ADDITIONAL INFORMATION - WRITTEN RESPONSE

REF: SD22A/0373

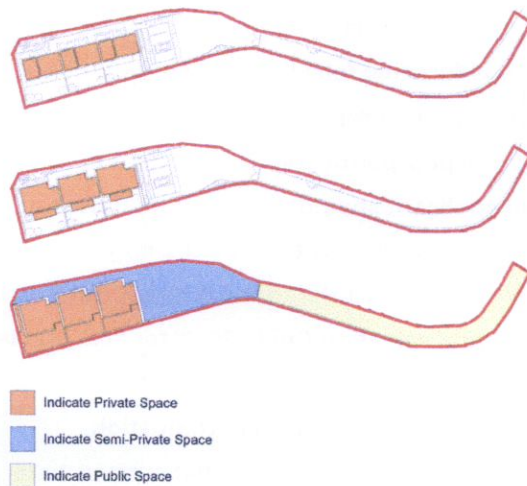
8. The applicant should demonstrate in table form the percentage (%) and area in sqm the of the proposed private, semi-private and public open space provision within the site.

Response: Please refer to the diagrammatic site plans and table below. As indicated on the site plans, the orange fill indicates private space, the blue fill indicates semi-private space, the yellow fill indicates public space. The areas have been displayed in percentage format in the table below.

Private Space	Semi-Private Space	Public Space	Total
Ground Level	365m ²	425m ²	385m ²	1,175m ²
First Floor	215m ²	-	-	215m ²
Second Floor	140m ²	-	-	140m ²
Total m²	720m²	425m²	385m²	1,530m²
Total %	47.1%	27.7%	25.2%	100%
